South Texas Project
Units 3 and 4
Docket Nos. 52-012 and 52-013
Revised Response to Request for Additional Information

RAI 09.01.02-9

Attachment: RAI 09.01.02-9 Response Revision 1

Summary: Provide additional information about the seismic loading for the nonlinear time history analysis of the spent fuel racks.

Figure 1 Comparison of Input vs. Calculated Response Spectra, Horizontal (X)

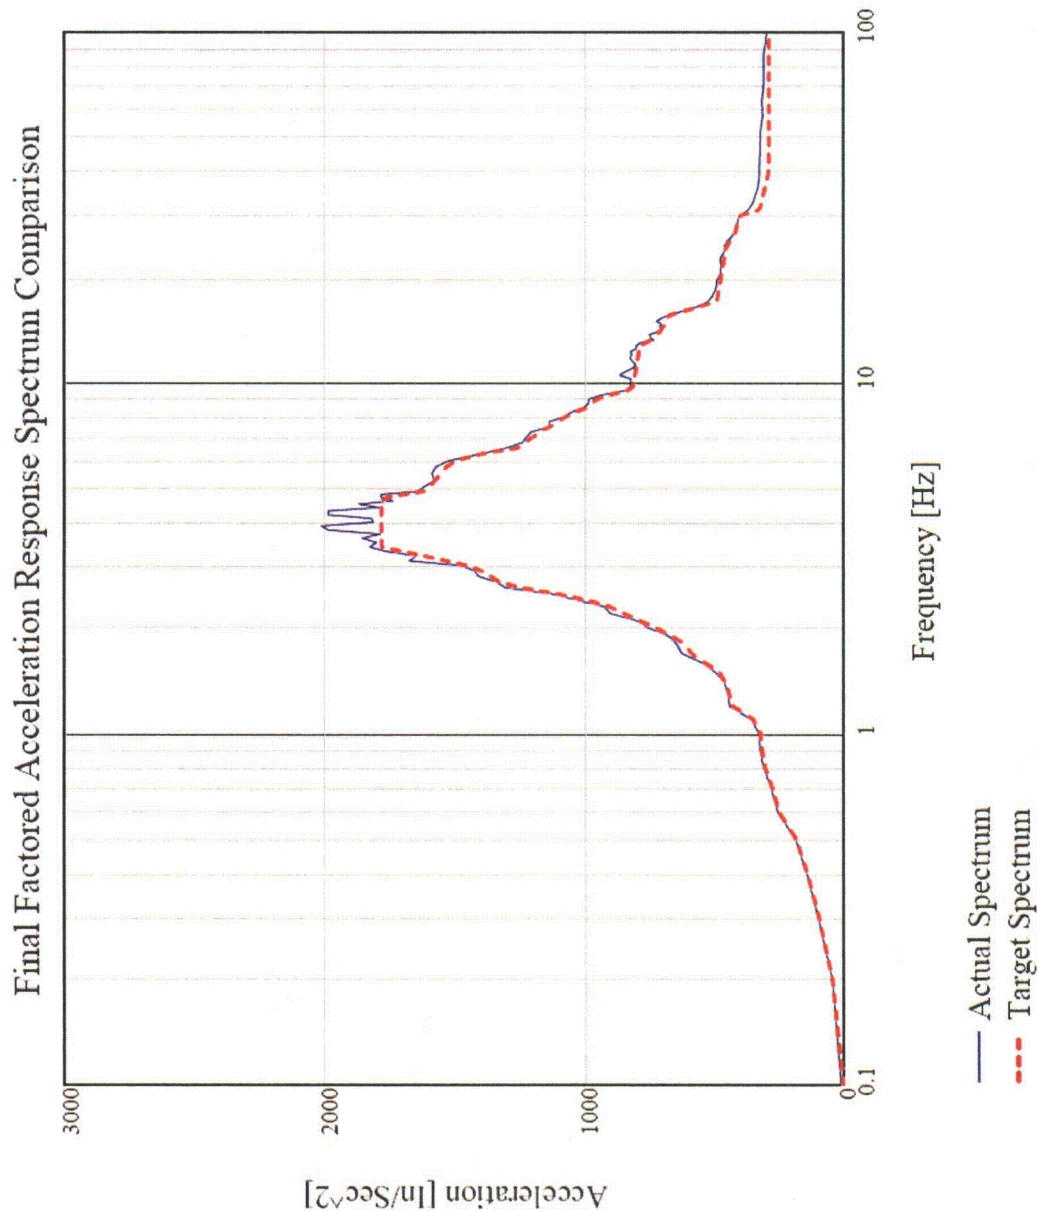
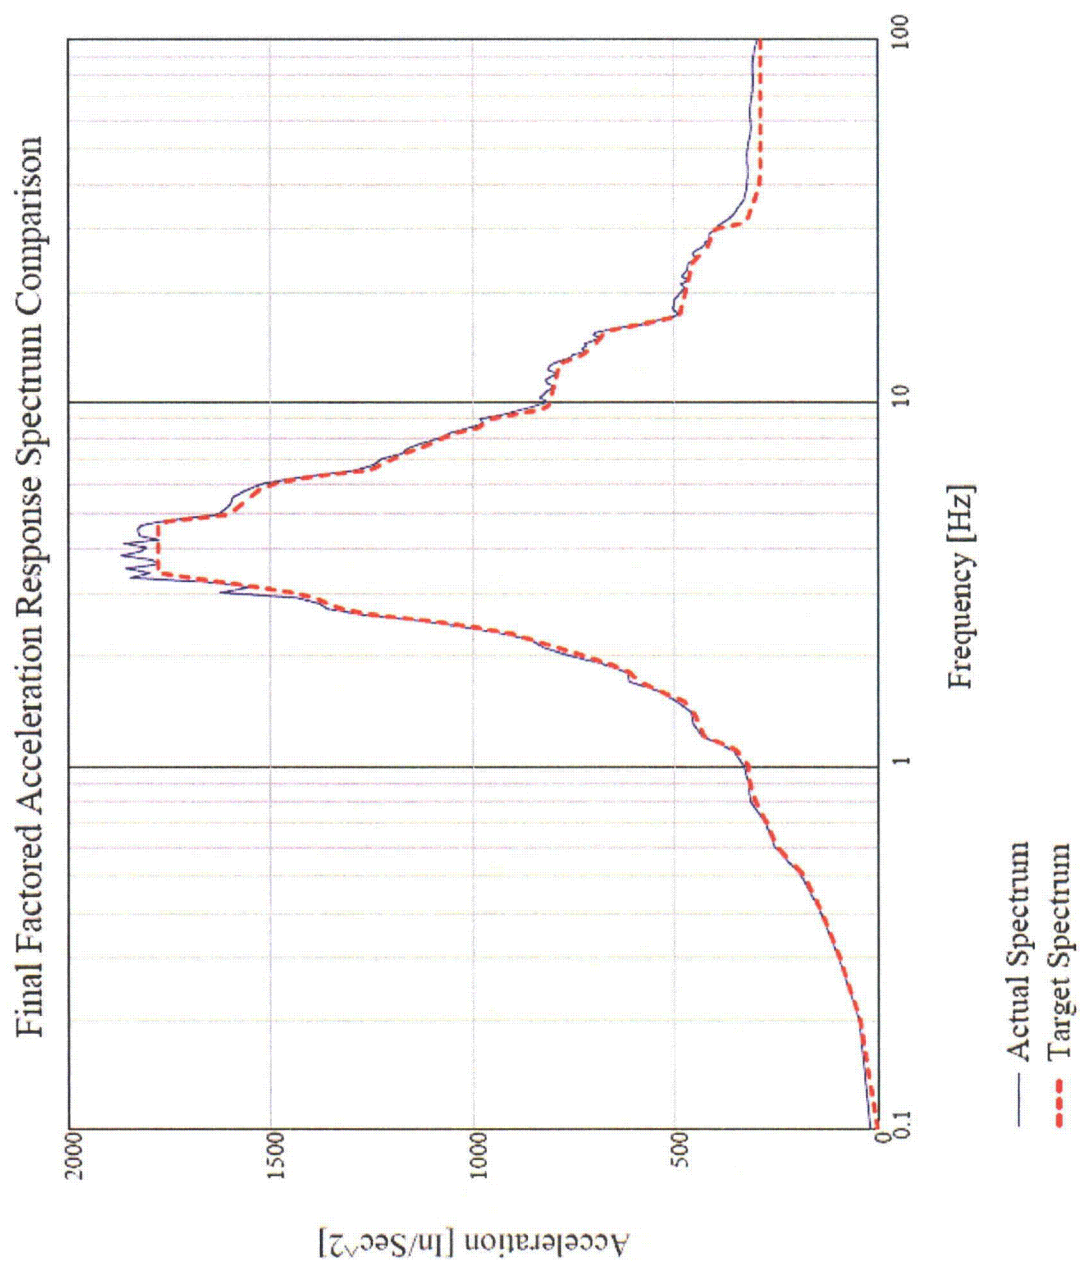
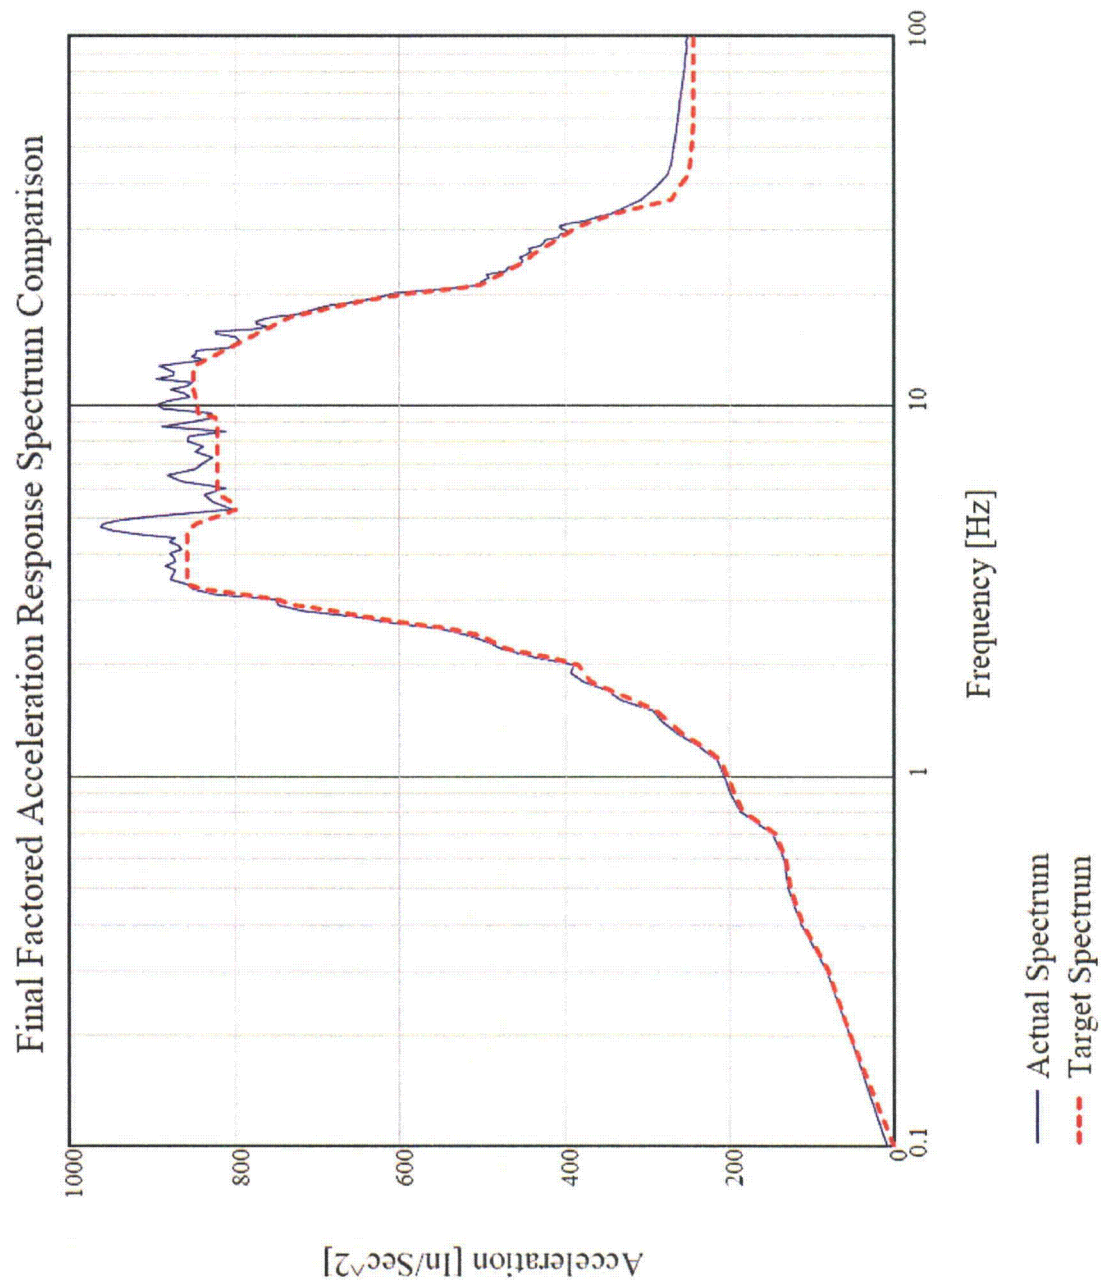
- a. Confirm that the 3 synthetic time histories have been checked against each other to ensure statistical independence. Compare the calculated correlation coefficients to the acceptance criterion of ≤ 0.16 . Include this information in the spent fuel racks technical report.
- b. Provide figures comparing the 5% damped spectra (2 horizontal, vertical) generated from the synthetic time histories to the 5% damped target spectra (horizontal, vertical) at node 100. Identify the criteria used to verify the adequacy of the match. Include this information in the spent fuel racks technical report.

- b. The following figures show the comparison of the 4% damped spectra (2 horizontal, vertical) generated from the synthetic time histories to the 4% damped target spectra (horizontal, vertical) at node 100. Per the requirements of NUREG-0800, Standard Review Plan 3.7.1, the SRP Acceptance Criteria on page 10 states that “Each calculated spectrum of the artificial time history is considered to envelop the design response spectrum when no more than five points fall below, and no more than 10 percent below, the design response spectrum.” Synthetic time histories were created for 4% damping at Node 100, per the requirements of Reg Guide 1.61, “Damping Values For Seismic Design Of Nuclear Power Plants,” as required for welded steel or bolted steel structural material with friction connections (RG 1.61, Table 1, “SSE Damping Values”), not the 5% as requested above.

The following table shows compliance to the NUREG-0800, Standard Review Plan Section 3.7.1 for Response Spectra Comparison (the number of points below the target is less than or equal to 5, and the maximum percent under the target is less than 10%):

Figures 1, 2, and 3 show that the synthetic generated time histories envelope the target response spectra using 4% damping at Node 100 for all three directions. This information will be included in the spent fuel racks Technical Report.

Figure 4 Actual Raw and Average PSD vs. Target – Horizontal (X)

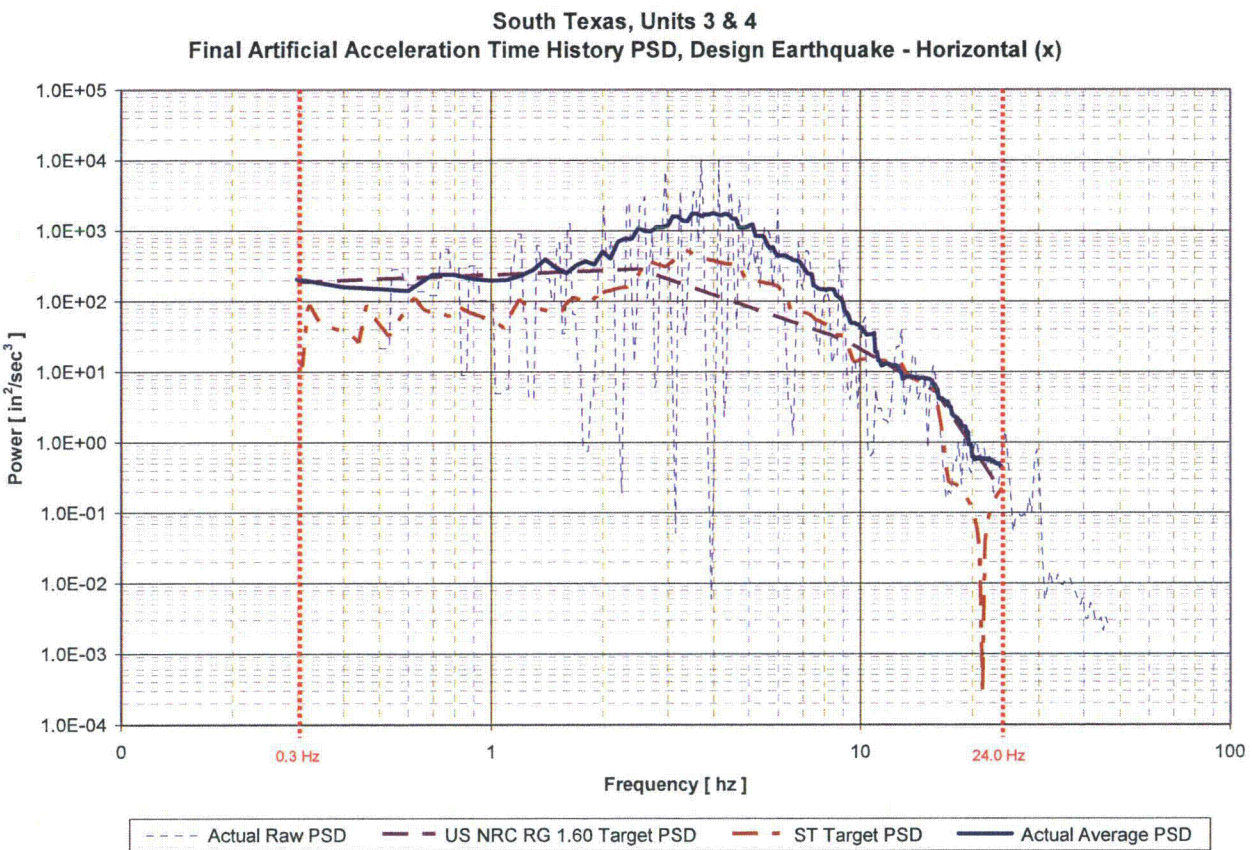
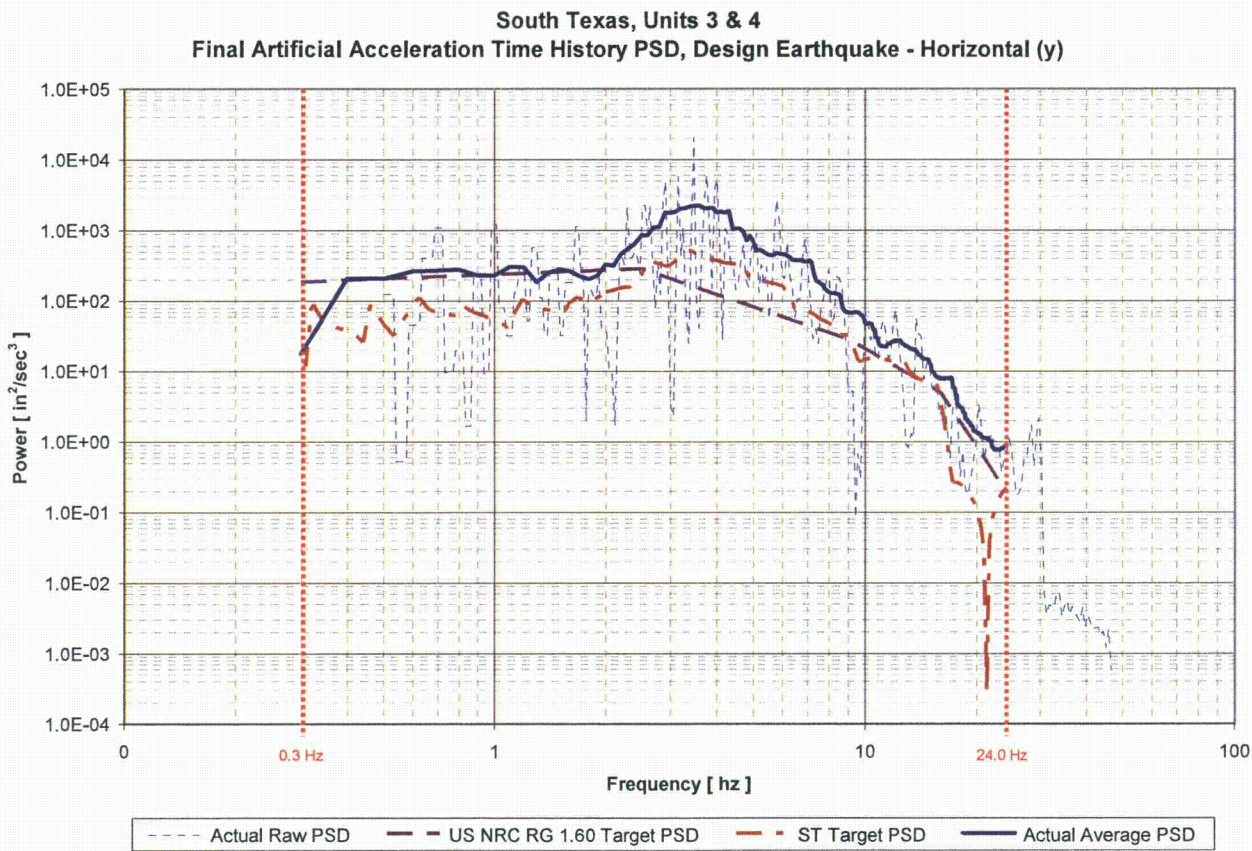
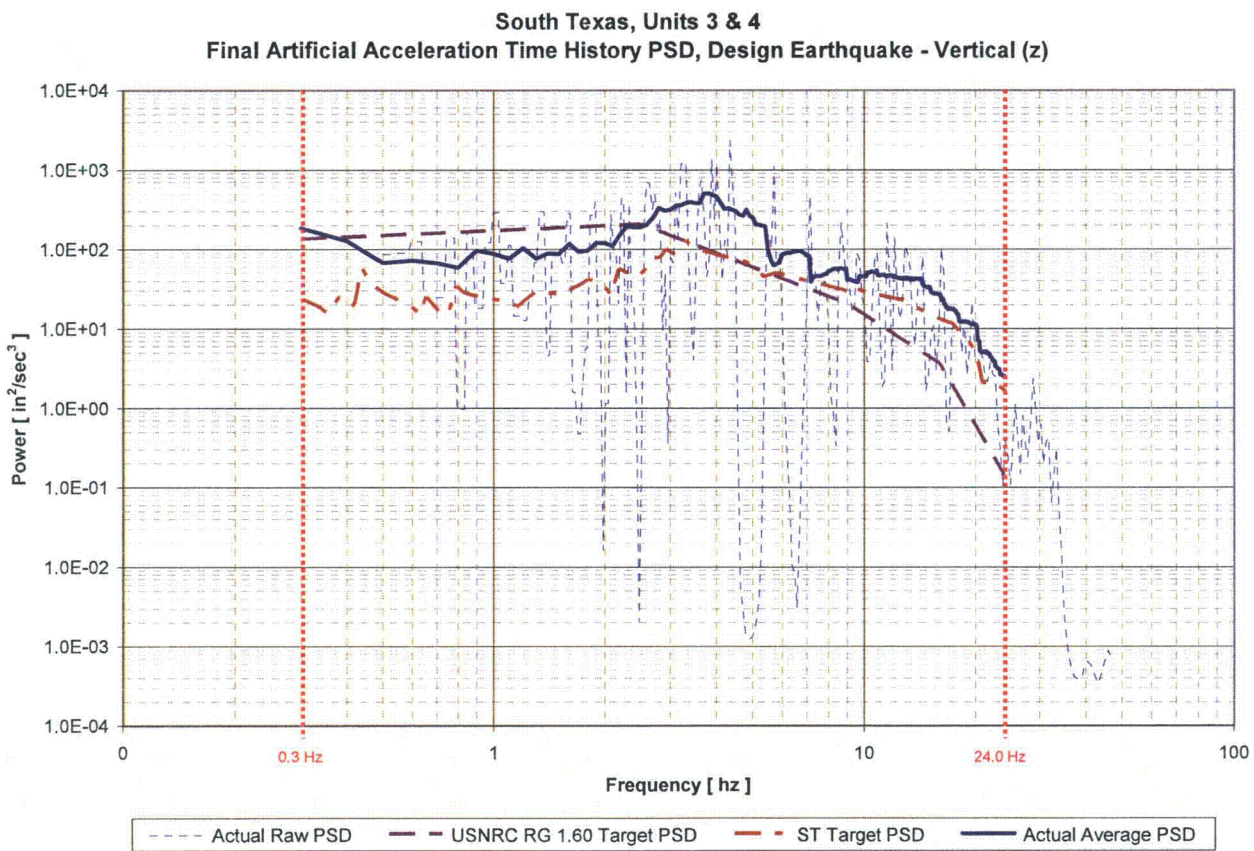
- c. Describe how target PSDs were developed for the Node 100 target spectra, and provide figures comparing the PSDs for the synthetic time histories to the PSDs for the target spectra. Identify the criteria used to verify the adequacy of the PSDs for the synthetic time histories.

Figures 4, 5, and 6 are plots of the 80% NRC target PSD function, the actual raw PSD, the actual average PSD, and the site-specific target PSD function for each case.

It can be seen that the actual average PSD curves are above the STP-specific target PSD curves with exceptions as follows:

- X direction, around 15Hz, the actual average is approximately equal to the target.
- Y direction, around 0.32 Hz, the actual average is below the target.

The PSD check that is required by SRP Section 3.7.1 is for synthetic motion generated at the ground level. Because the STP 3&4 synthetic motion is at a higher elevation within containment, the PSD check has been conservatively applied at the higher elevation. There are two small frequency ranges (between 0.3-0.4 Hz in the horizontal "Y" direction and

between 10-20 Hz in the horizontal “X” direction) where the actual PSD is below the site specific target PSD. The actual PSD is very close to the target PSD within these frequency ranges, and because the input response spectra is at an elevation above ground level, the artificial time history data is deemed acceptable.
